**Ryan Corner Wind Farm - Changes to endorsed Traffic Management Plan**

## Ryan Corner Wind Farm Traffic Management Plan

Date: **24 March 2017**  
Reference: 43315958/01/05  
Status: Final

**Figure 2-3 OD Vehicle**

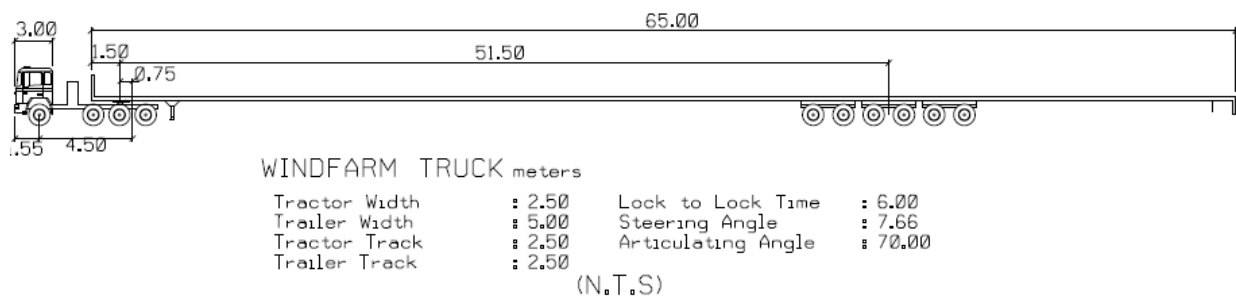
The proposed increase in turbine size will require the size of the OD vehicle transporting the turbine blades to increase from 56.61m to 68.80m (Figure 2.3). This OD vehicle has the largest turning requirements of all the OD vehicles delivering the wind turbine components to site (Figure 2.4).

Figure 3-9 Turning Movements - Princes Highway / Youls Road Intersection

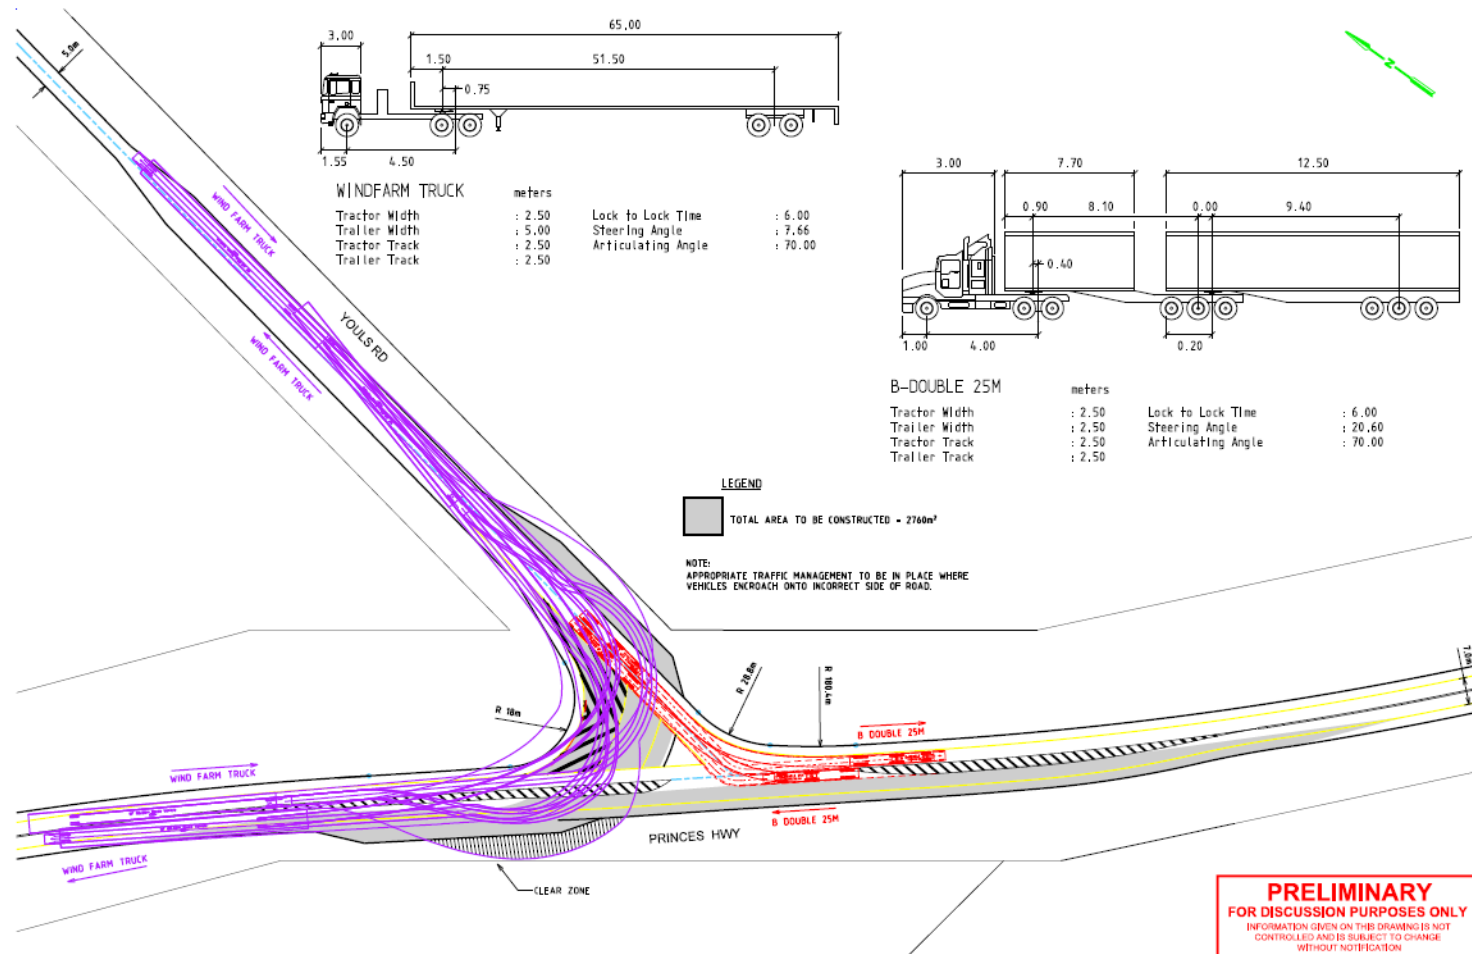
An increase in area of road reserve used to construct the pavement at the intersection of Princes Highway and Youles Road (The area of pavement required is reduced from 3,170m<sup>2</sup> to 2,766m<sup>2</sup>), to facilitate the movement, the majority of which is in the north-west corner of the intersection. An increase in the clear zone within the road reserve will also be required. These changes will have minor \ moderate impact.
